LEReC INSTRUMENTATION DEVELOPMENT

6-20-15

T MILLER

Scope: Transport

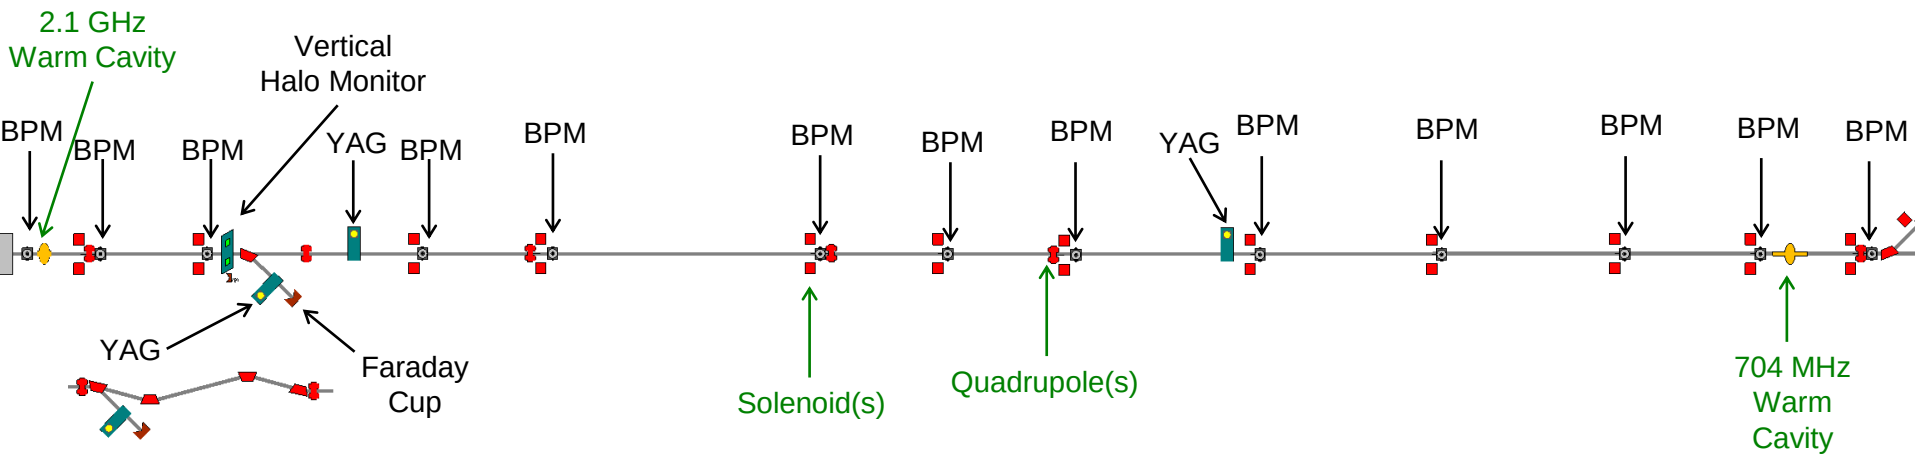
1. 1st Diag. B/L for commissioning
2. Do we need to add YAG in transport?
3. REVISED LAYOUT BELOW:

Emittance Slit Mech Design

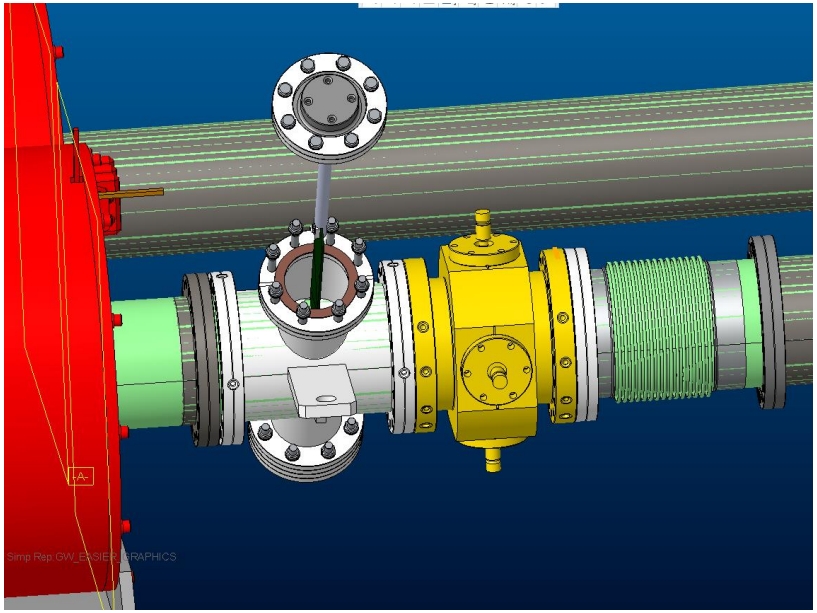
The attached picture shows the EMS in the beam line. The chamber length is specified in the general system spec. and the flanges are fixed. The scanner port does not allow for the bolts to be inserted from the scanner side into the BPM chamber. There are a number of options to consider.

1. Referring back to the attached picture, there appears to be enough room to increase the chamber length and permit bolt installation
2. use a rotatable flange on the scanner chamber and preinstall bolts into the flange and rotate the flange into position
3. maintain the fixed flange and preinstall the flange with studs prior to assembly
4. move the port off chamber center away from the BPM and adjust the scanner chamber support design.

Our preference is to increase the chamber length if permitted.

Can we increase the length of the chamber by ~1 inch? (YES)

Is there a specific location for the mask plane either relative to the lattice or to the profile monitor that must be maintained?

Cooling BPM Design

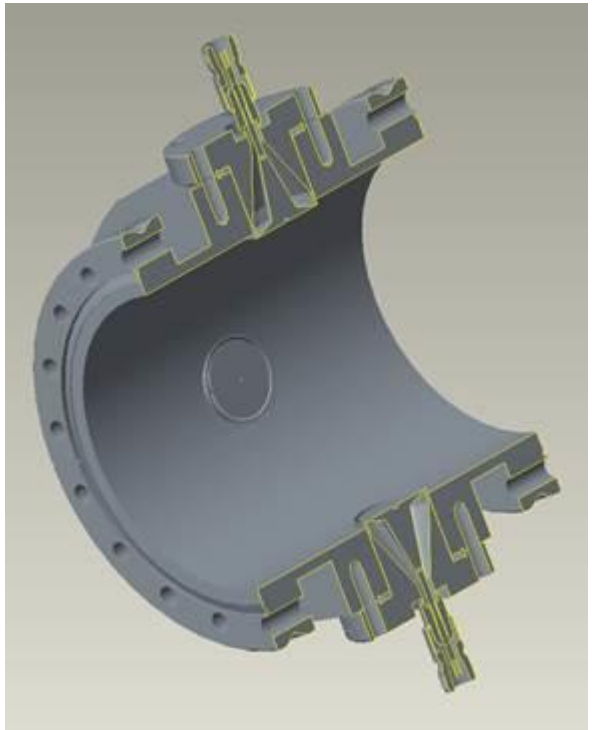
I've asked Vito to make two more drawings, each with min & max extreme tolerances that shows the full range of possible distances from the side of the button face to the adjacent housing aperture ID. Peter T has tentatively agreed to relax the +0.000/-0.004 as long as the distance of opposing buttons to the beam line center is as accurate as possible (+/- 0.002).

Result range is recess of 0.030" and protrusion of 0.013"

Need to schedule a Final Design Review with MPF next week.

Before that meeting we need to finalize:

All tolerances and dimensions

The production schedule, present deliver is Feb 2016

If we can have guaranteed acceptance of components without change, we can cut the schedule nearly in half. Please let us know if we can order any or all of any components.

Profile Monitors

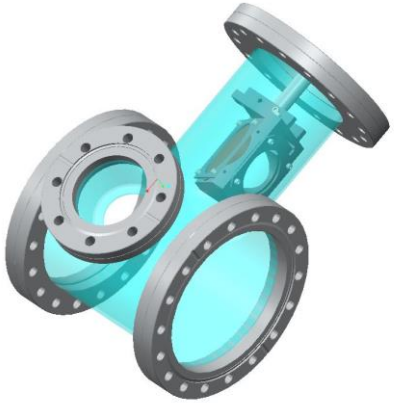
- Cooling Section PMs
  - Vacuum chamber modified
    - Enlarged 1.75” optics port penetration to 2.37” for illumination & ease of fabrication.
    - Simulation shows acceptable results.
  - 100µm YAG current choice
  - Ferrite temp rise due to 19mW => 2.2°C (low enough to disregard)
  - 20cm Radius of Mu Metal puts optics assembly ~20cm away from YAG crystal

- Transport ERL PMs
  - Beam size (4mm sigma) in TWO transport PMs too large for 25x15mm YAG
    - require redesign of YAG & holder for TWO PM’s
    - Location of 25x15mm YAG PMs needs to be determined
      - All in transport (2 with modified – larger – YAG crystals)
    - Need beam size simulation in energy spectrometer beam line
  - Cage in all 5 ERL PMs will require modification
    - Addition of ferrite rings
    - May require single contact point in vacuum

Enhanced Energy Spread Measurement

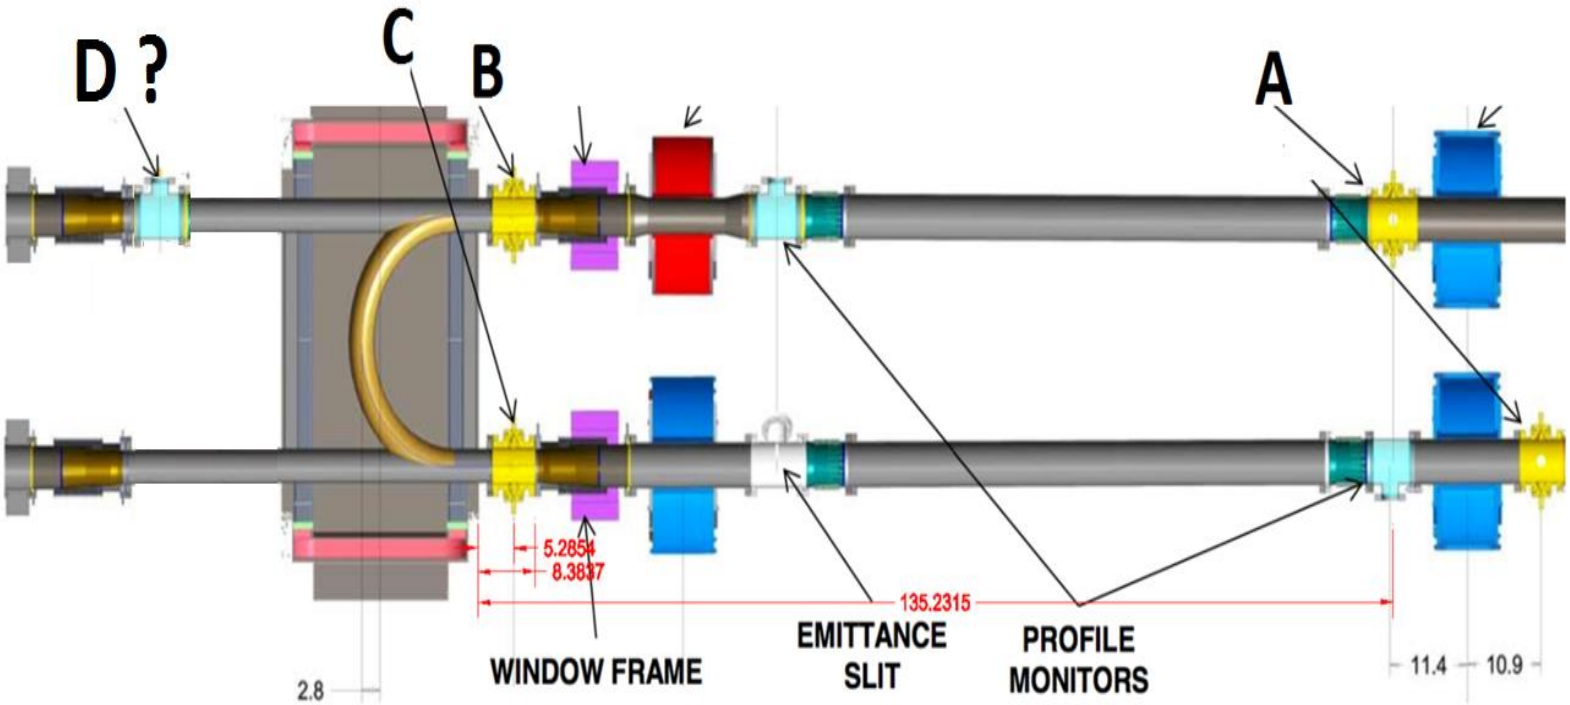
1) Install a slit on the YAG actuator in B
2) Install a profile monitor D at a distance BD equal to the trajectory length from B to C

A better energy measurement would result with a smaller image at C
A better energy spread measurement would result by comparing beam spot widths at D and C. The red solenoid would not need to be strong and could have steering correctors.
